COMMERCIAL ENGINE BULLETIN

ENGINE, FUEL AND CONTROL - HYDROMECHANICAL UNIT (HMU) -ONE-TIME TORQUE OF METERING HEAD REGULATOR COVER BOLTS

EMC-35A HMU 73-31

Goodrich Pump & Engine Control Systems, Inc. MODEL EMC-35A Hydromechanical Unit Assembly One-Time Re-Torque of Metering Head Regulator Cover Bolts

HMU Housing Figure 1

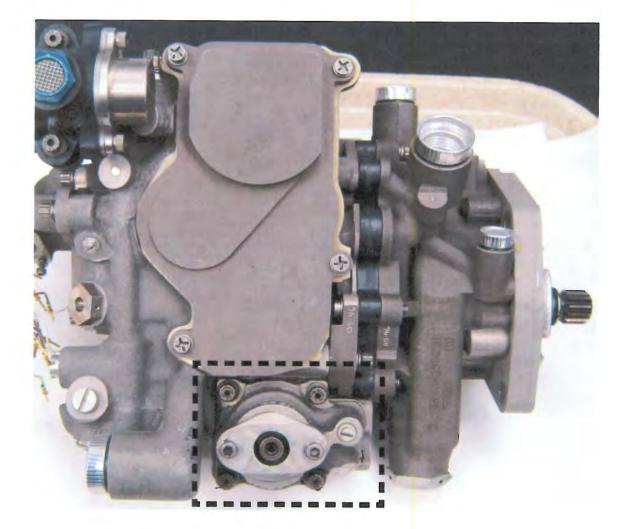
To be complied with within 150 operating hours. Until such time that compliance is accomplished, a visual leak check of the MHR cover parting line (see Figure 1) must be completed on a daily basis prior to each flight.

- B. Locate the MHR cover on the HMU as shown in Figure 1. The cover is facing down if the HMU is installed.
 - NOTE: In the following step, it is important that the cover bolts are not backed out by any amount. Bolts must be rotated in the clockwise direction only, when facing the HMU.

Metering Head Regulator Cover - Torquing Sequence Figure 2

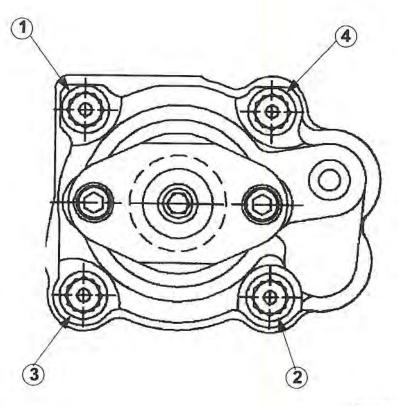
A small number of HMUs have been found to exhibit weepage at the parting line of the Metering Head Regulator (MHR) cover to the HMU housing. In most cases no measurable leakage is found, but wetting at the parting line is observed. Investigation has revealed that a majority of returned HMUs are found to be insufficiently torqued at one or more of the four bolts securing the MHR cover to the housing. The allowable bolt torque limits on the MHR cover have been increased to prevent leakage.

- C. Using a calibrated torque wrench and the bolt sequence shown in Figure 2, torque the MHR cover bolts to 34 38 in-lbs (3.85 4.30 N-m) in accordance with standard maintenance procedure.
